**Historical Architectural Review Board  
COA Final Review Sheet**

**HDC-2023-00082**

**Address: 531 W. Allen Street**

**Proposal: Remove slate shingles; install asphalt shingles**

**Detail of roof, 2019.  
(Google StreetView)**

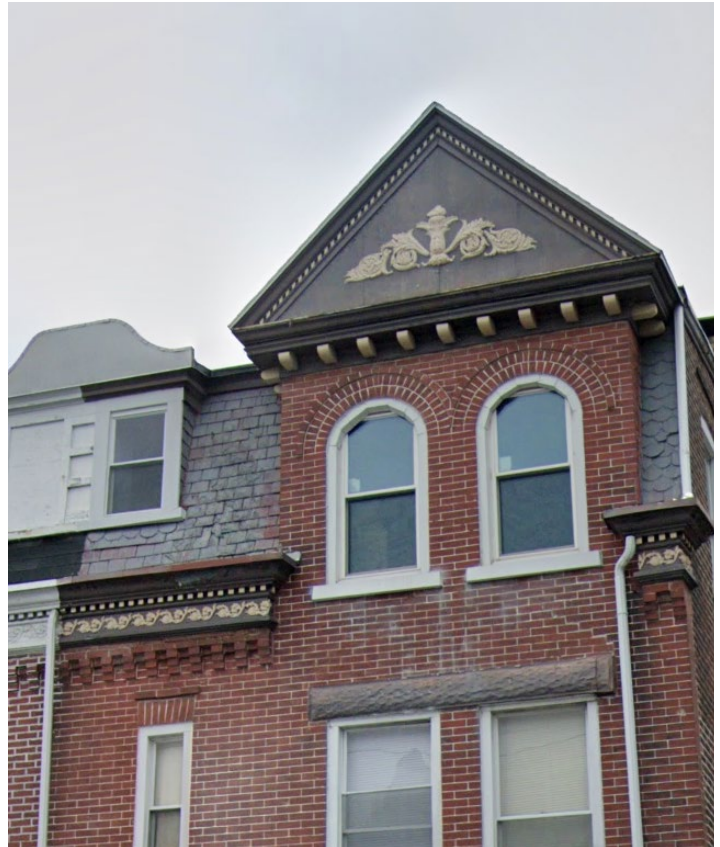
The applicant contends that the existing slate roof is failing and in poor condition. Photographs show that there are displaced shingles throughout the roof. Staff notes that the roof currently contains slate shingles in rectangular and beveled shapes, though there is no discernible patterning. Based on the beveled slate shingles at 527 and 529 W. Allen Street, staff contends that the mansard at 531 W. Allen Street historically had beveled shingles and that rectangular shingles were installed to replace many of the failing original shingles; however, no documentation exists to confirm this assumption.

Mr. Huber agreed with staff that the historic shingles were likely beveled and many were replaced with rectangular shingles over time. He stated that most of the original shingles are missing, and that the proposed GAF Slateline shingles provide a close match to most of the existing slate shingles. The HARB agreed that the proposed shingles are appropriate.

GAF Slateline in English gray.  
(www.lowes.com)

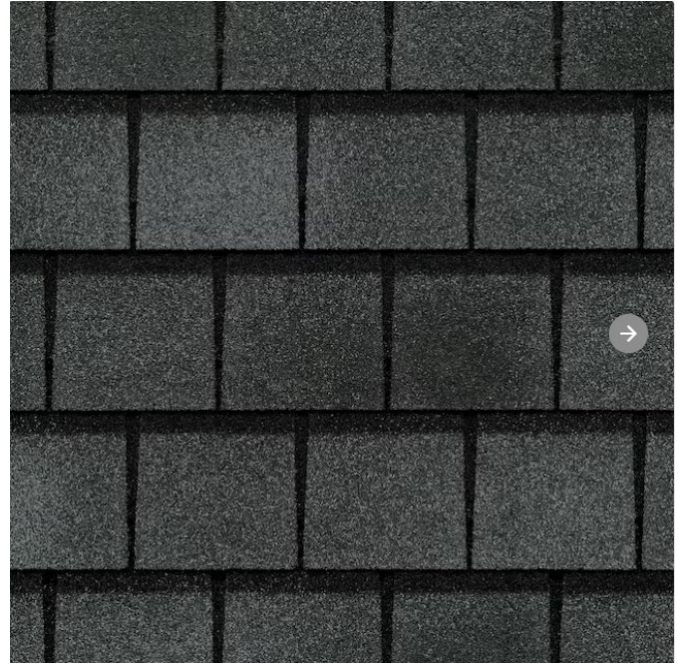
The application proposes to install GAF Slateline shingles, which are an appropriate alternate that generally match the existing rectangular slate in dimension, shape, profile, color, exposure, and overall appearance. Staff finds that the proposed shingle complies with the guidelines in Section 3.1 Roofs.

Approval, pursuant to Chapter 3, Section 3.1 Roofs.
